Work Order ID 114502

Item Name: Mounting Lug

DRAWING NO. D2731	TITLE MOUNTING LUG	REV. C	DART AEROSPACE USA, INC ENGINEERING ORDER		D.E.O. NO. D2731-C-1	SHEET NO. SHEET 1 OF 1	SCALE NTS
DRAWN <i>qp</i>	CHECKED <i>sc</i>	MFG. APPR. <i>M</i>	APPROVED <i>MD</i>		DE APPR. <i>MD</i>		
DATE 11.05.02	DATE 11.05.09	DATE 11.05.09	DATE 11.05.09		DATE 11.05.09

ADD D2731-xRG OPTION

D2731-1RG MOUNTING LUG (SHOWN)
D2731-3RG/-5RG/-7RG MOUNTING LUGS (SIMILAR)

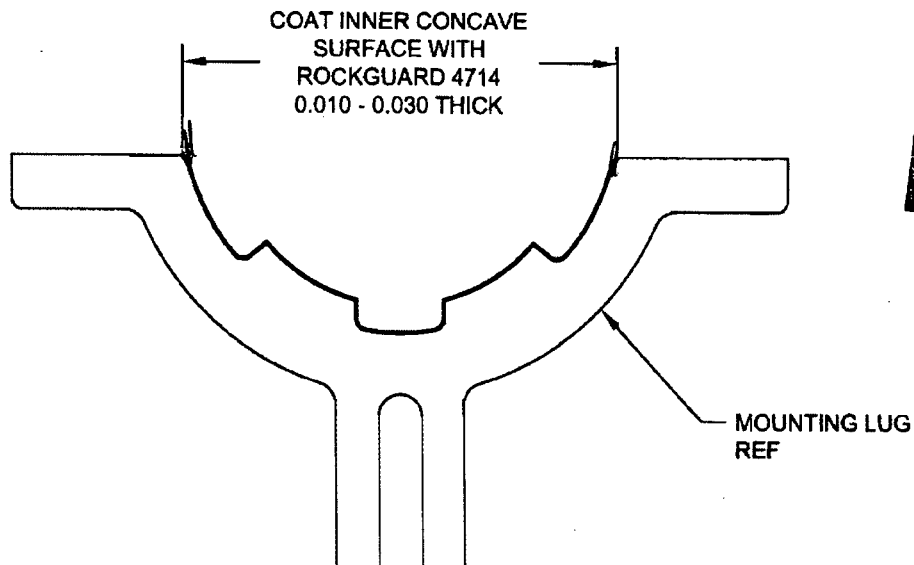
D2731-xRG MOUNTING LUGS ARE INDENTICAL TO D2731-x MOUNTING LUGS, HOWEVER AFTER FINISH, COAT INNER CONCAVE SURFACE WITH "PLUS ONE ROCKGUARD 4714" AS SHOWN BELOW.
